# Service Bulletin

Bulletin No.: PIP4844B

**Subject:** TAC Part Restriction - Accessory Power Module (APM)

**Models:** 2011-2013 Chevrolet Volt

3256768

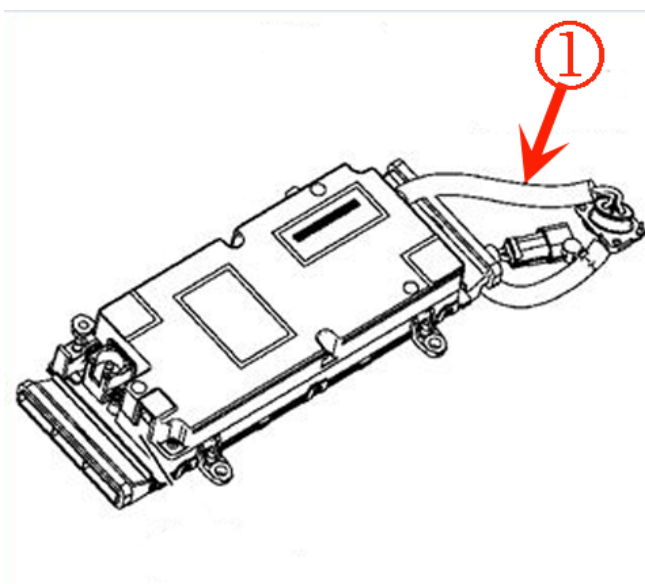
The first design APM has a 24 inch orange pigtail attached to the APM and there is no high voltage connection right at the APM itself (See Photo Below)

All model year 2011-2012 vehicles will need a first design APM.

All 2013 model year vehicles built before VIN break: 1G1RA6E46DU120394 will require the first design APM.

3256773

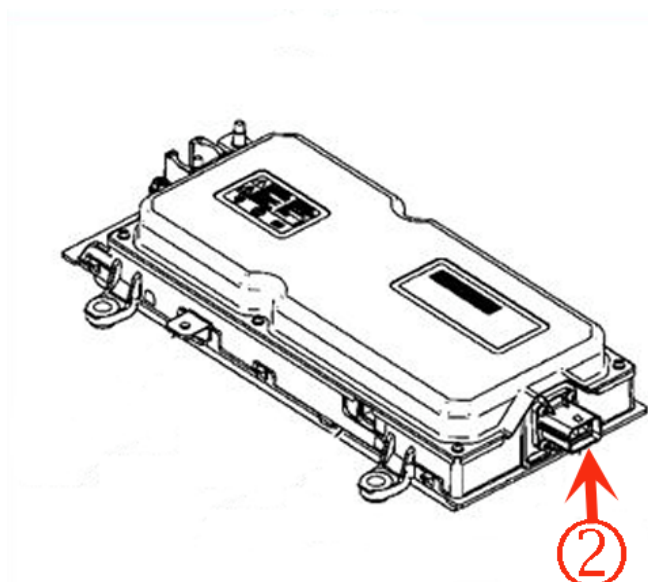
The second design APM has no pigtail and the high voltage connection is right at the APM itself (See Photo Below)

All 2013 model year vehicle built on or after VIN break: 1G1RA6E46DU120394 will require the second design APM.
